#### ALPINE CITY PLANNING COMMISSION MEETING

**SUBJECT:** Exception Request – Gateway Historic & Business Commercial

**SUBJECT:** Exception Request – Gateway Historic & Business Commercial

**SUBJECT:** Public Hearing – Amendment to Ordinance – Article 3.3.4 and Article

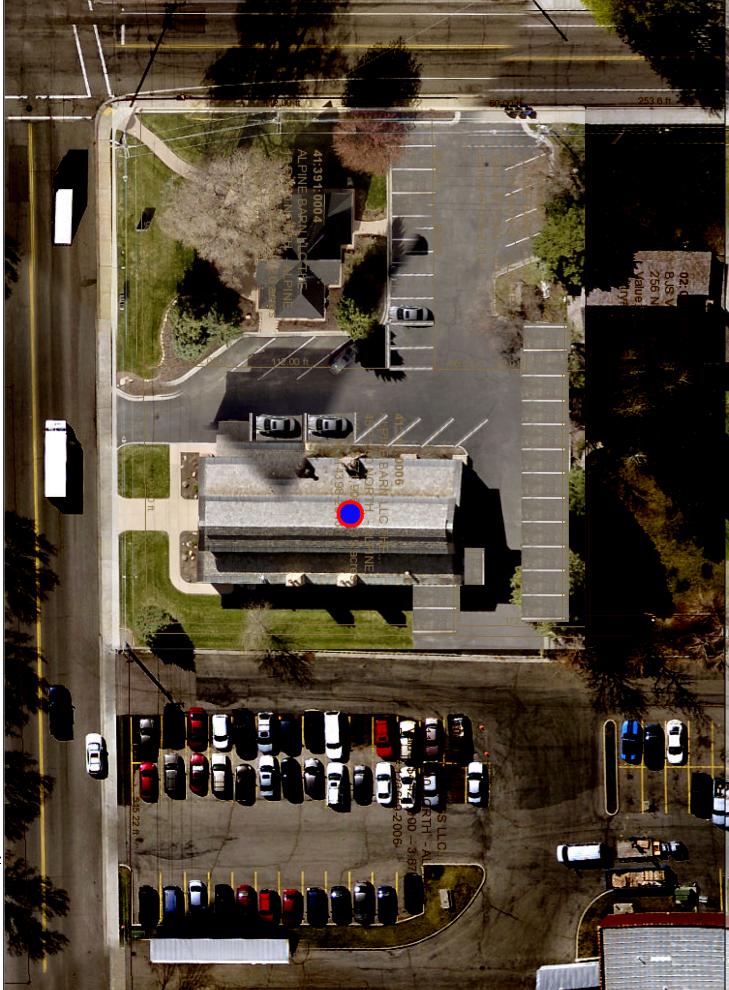
The petitioner, Dylan Ense, has submitted a request for an exception to the off-street parking requirement for a reception center. The property is located at 45 East 200 North. Plans for the proposed parking show 18 spaces on the subject property, 21 spaces on adjacent parcels owned by the same landowner, and an additional 13 spaces at the D&M Holdings Property on the other side of 200 North. In total, 52 off-street parking spaces would be provided.

According to Alpine City Development Code Article 3.24.3 reception centers are required to provide 13.5 parking spaces for every 1,000 sq. ft. for buildings 20,000 sq. ft. or less. The subject structure is approximately 4,500 sq. ft. Ordinance would require 61 spaces based on the approximate sq. ft.

The proposed site for the reception center is located next to Purple headquarters, who has a history of parking issues. Staff recommends that if the proposal is approved that the hours of the event center be limited to mitigate the impact to neighboring properties and area.

Staff recommends approval of the proposed parking exception with the following conditions:

- Written agreements be required from landowners for all off-premise parking.
- The event center be limited to operating hours that will minimize the impact to the neighboring properties and area.

2018-9-12 BANK OF AMERICAN FORK ALPINE BRANCH REBUILD PROPOSAL.pdf 7910K

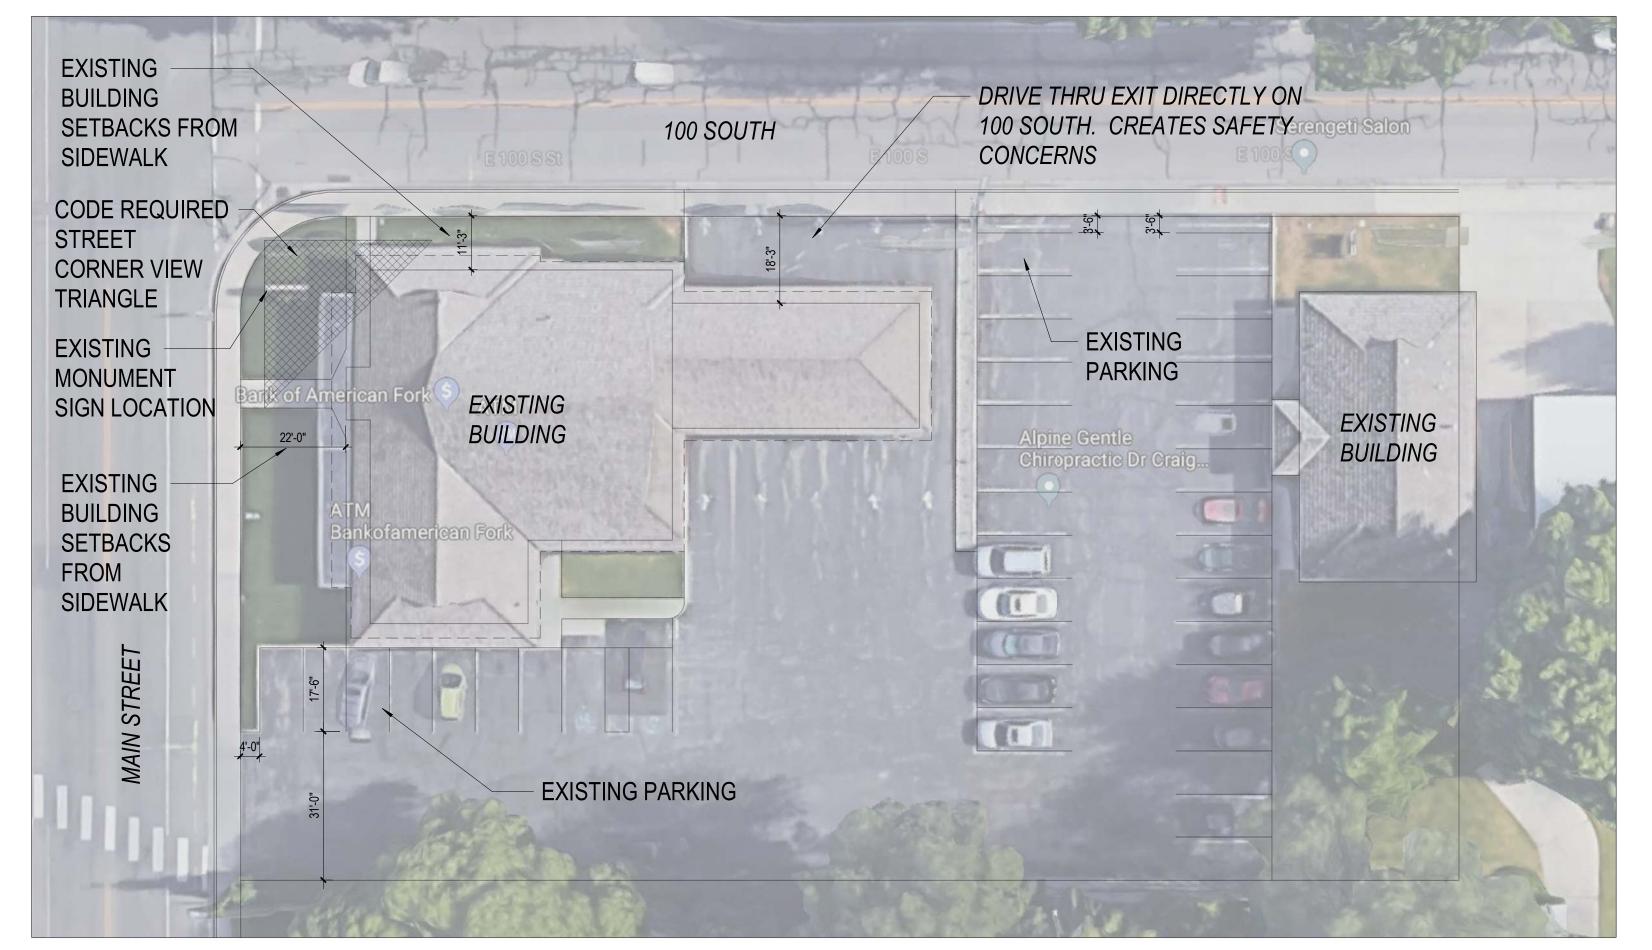
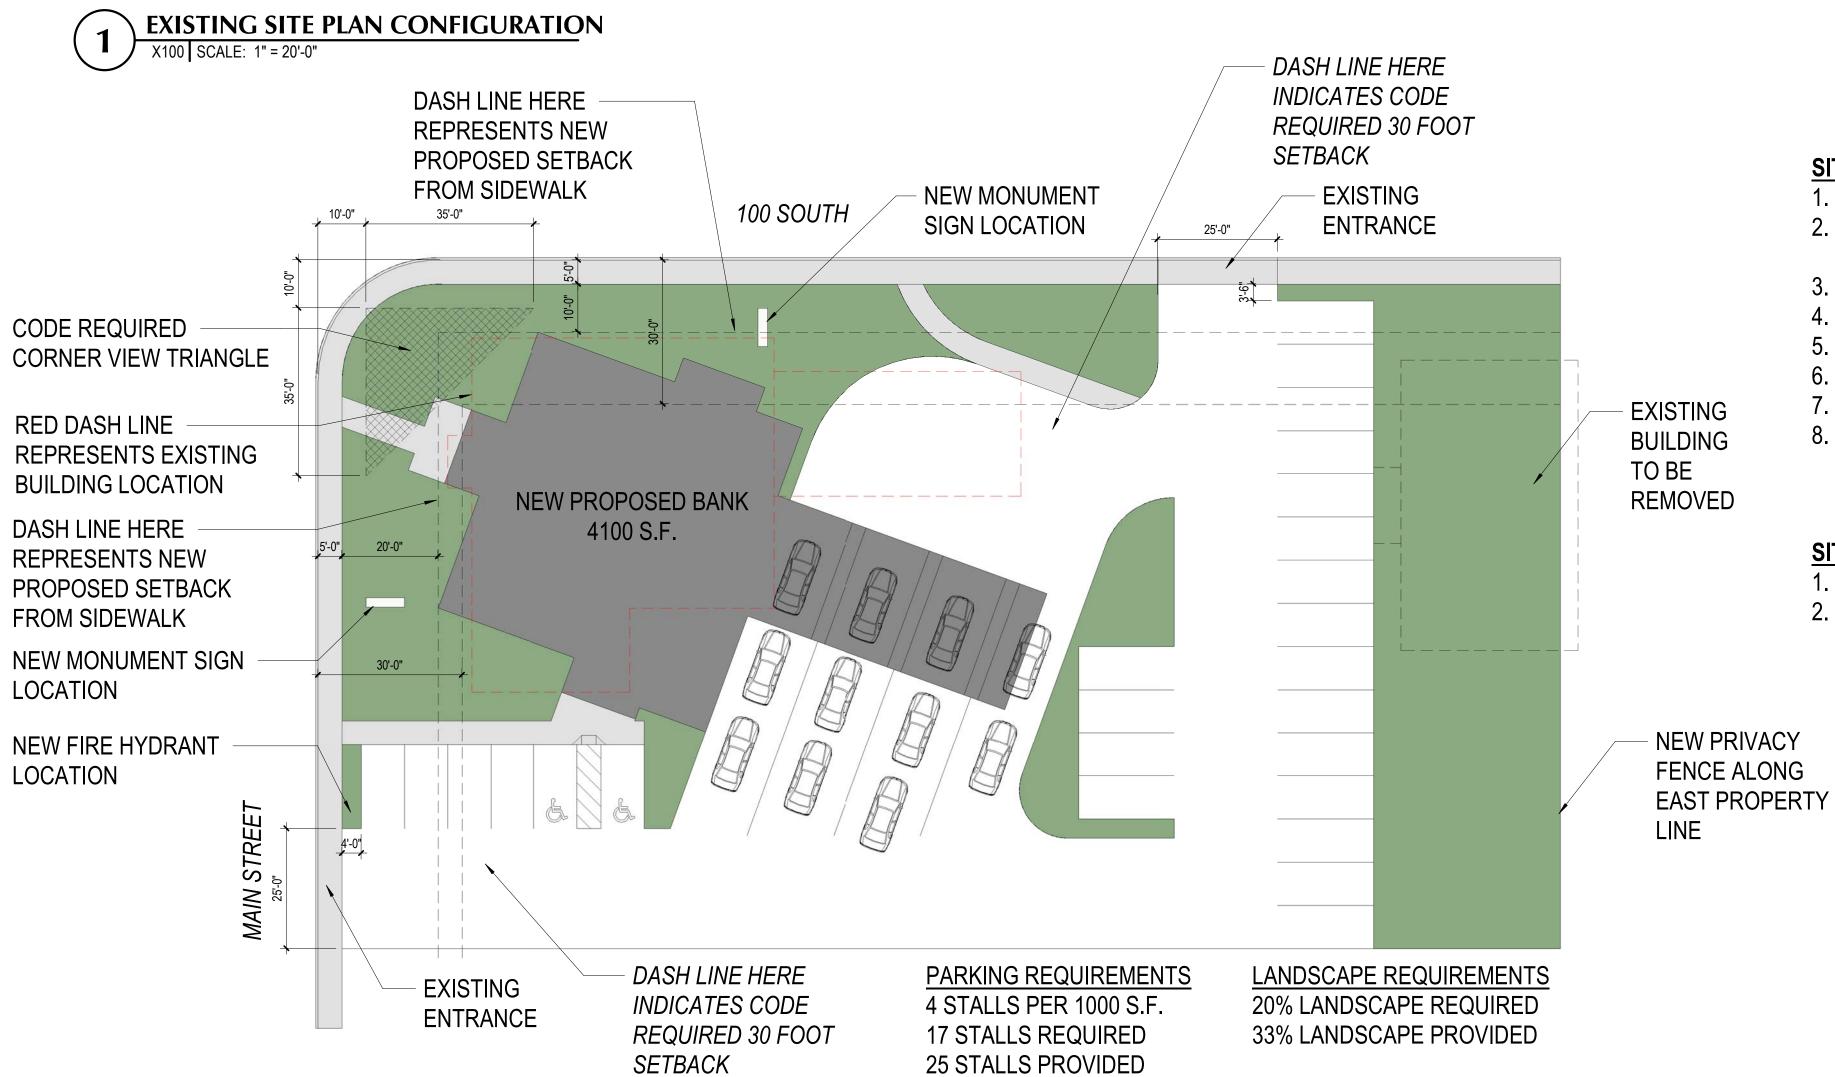
The petitioner, Bank of American Fork, has submitted a request for an exception to the setback requirement for the Business Commercial Zone. They are proposing to build a new building on the property located at 105 South Main Street. Plans show setbacks of 10 feet on the northerly end of the property off of 100 South, and 20 feet on the westerly side of the property off of main street.

According to Alpine City Development Code Article 3.7.5.1 buildings shall be setback not less than 30 feet from the property line on all streets.

The current Bank of American Fork building has setbacks of approximately 11 feet off 100 South, and 22 feet off Main Street. The new site plan does not deviate greatly from the setbacks of the current building.

Staff recommends approval of the proposed setback exceptions.

## EXHIBIT A 2014 PROPOSED LAYOUT VS APPROVED AFTER ORDINANCE CHANGE

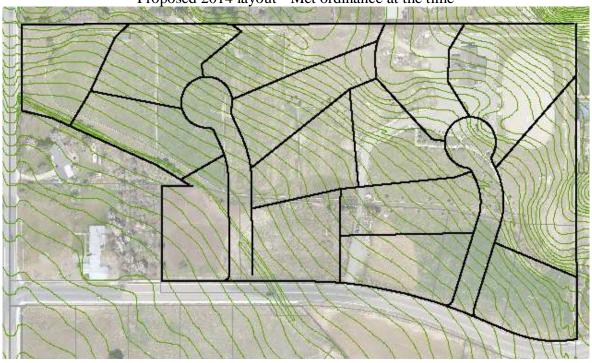
In 2014 the City was approached by a developer claiming the process to determine density was cumbersome and produced oddly shaped lot lines, leaving the City and future home owners with undesirable lot layouts. The layouts created irregular lots lines which don't make sense to the lot owner when it comes time to put in a fence, find their property corners, landscape their yards, etc. Exhibit A shows the lot layout proposed under the old ordinance vs what the layout could look like based on their ordinance change proposal. Their proposal was to take the PRD ordinance density calculations and apply them to standard subdivisions. The City looked at their proposal, agreed it would clean up lots lines, and made the modifications to the ordinance.

Prior to this change average slope of a lot was a determining factor in overall density. Depending on the average slope of each lot, there were requirements for total area and frontage widths. The restrictions that the average slope requirements brought with it were the reason for irregular shaped lots. When the ordinance was changed, the area and width requirements were eliminated.

With development continuing to creep into the steeper areas of the city Staff has realized that more lots are being (or would be) allowed on the hillsides of the city than would have been with the previous code due to the lack of the area and width requirements. The City Council and Planning Commission have consistently tried to preserve the spacious feeling and visual openness of the city with hillside protections and zoning ordinances. The previous sections of code (3.3.4/3.4.4) were one example of that. Staff feels it would be in the City's best interest to re-instate previous code regarding density, lot area, and lot width requirements. Staff would also recommend there be a process to eliminate the irregular shaped lot lines created by the previous code. It is Staff's recommendation that the Planning Commission review and recommend to the City Council the proposed changes as noted below. Included as Exhibits B and C are clean versions of the proposed changes.
